KKK-A-1822A
AMENDMENT -2
JULY 1, 1983
SUPERSEDING
AMENDMENT -1
APRIL 1, 1981

FEDERAL SPECIFICATION

AMBULANCE

EMERGENCY MEDICAL CARE SURFACE VEHICLE

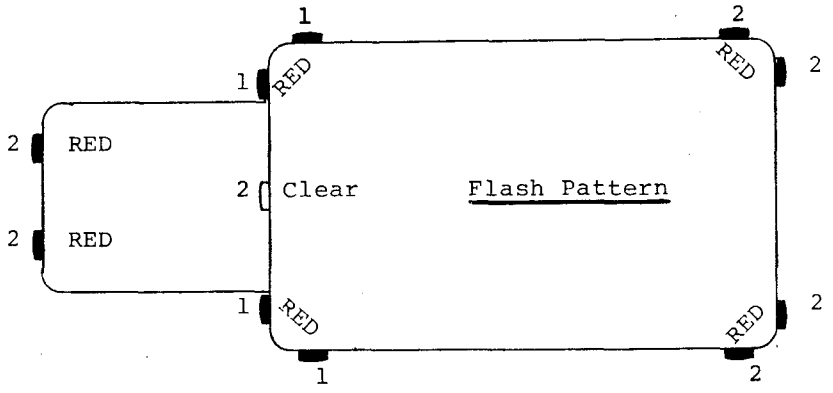
DELETE "FLASH PATTERN" AND SUBSTITUTE THE FOLLOWING:

1 - INDICATES LIGHTS FLASHING AT THE SAME TIME
2 - INDICATES LIGHTS FLASHING 180° OUT OF PHASE WITH 1
**THE "TERTIARY MODE" WHICH USES THE VEHICLE'S 4-WAY FLASHERS (DIRECTIONAL SIGNALS) SHOULD ONLY BE USED WHILE THE VEHICLE IS STATIONARY.
